ADDENDUM NO. 3

Re: **UMMC Roofing Repairs and Replacements (Wiser Hospital)**
(University of Mississippi Medical Center)
Jackson, MS
Project No. 409-008

**Roof Repair and Replacement
 (Wiser Hospital)
 The University of Mississippi Medical Center
 (jackson, mississippi)**

EXHIBIT "A"
 SHEET 1 OF 1

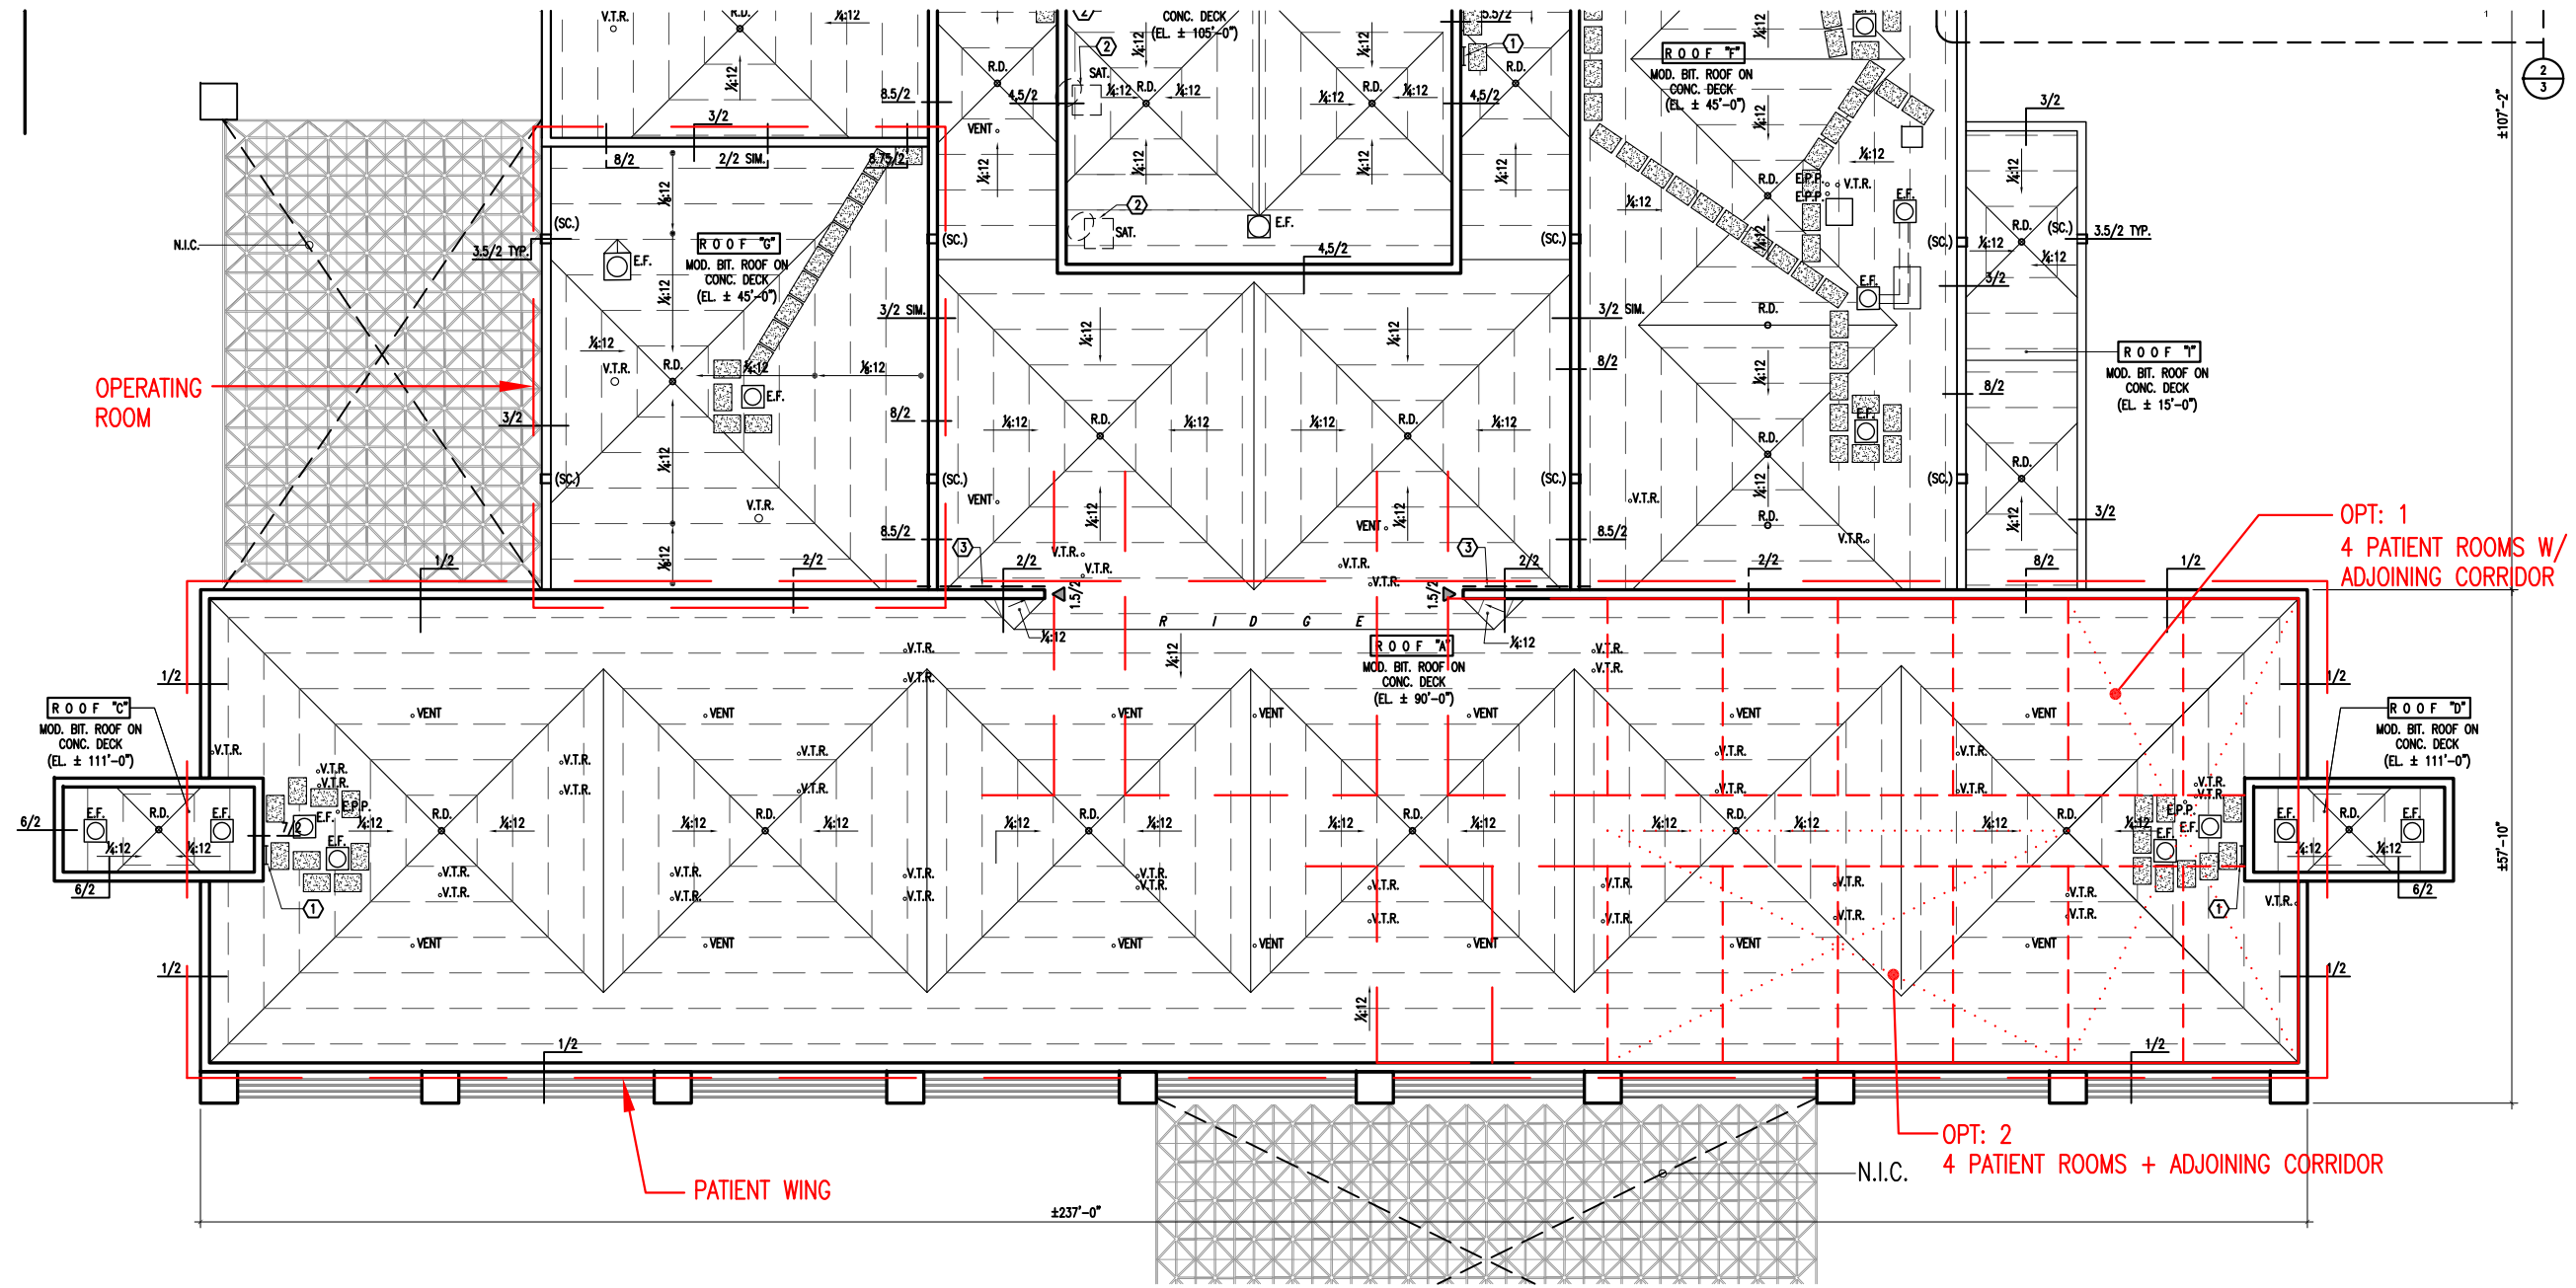
- A. The long east-west wing of Roof "A" (facing Woodrow Wilson Avenue) is a patient wing (see attached Exhibit "A"). The existing insulation system at Roof A is wire-reinforced lightweight insulating concrete, on structural concrete decking. A maximum of a four (4) patient room (+ adjacent corridor) footprint will be vacated and given *at one time* to the contractor to tearoff/roof above. The existing lightweight insulating concrete may not be jackhammered, or hammered on with conventional hammers, to remove the LWIC: the LWIC tearoff cannot create an acoustical disturbance in the patient area below. A tearoff trial has been conducted (see attached photos), where LWIC was sawn up into pieces, and the LWIC was removed in larger pieces from the roof. Whatever method is selected for removing LWIC, the removal method shall not involve jackhammering or hammering, and shall not create a disturbance to patients below. All work on this patient wing shall be conducted between 6:00 A.M. and 6:30 P.M.

1. The north-south "T"-wing of Roof "A" (surrounding the penthouse, Roof "B") is NOT patient area, and can be torn off in larger areas manageable to contractor (use same removal methods as used at main patient wing—no jackhammering).

2. Per Exhibit "A", four (4) patient room with adjoining corridor tear-offs may be configured as "Option 1" (crossing corridor), or as "Option 2" (paralleling corridor).
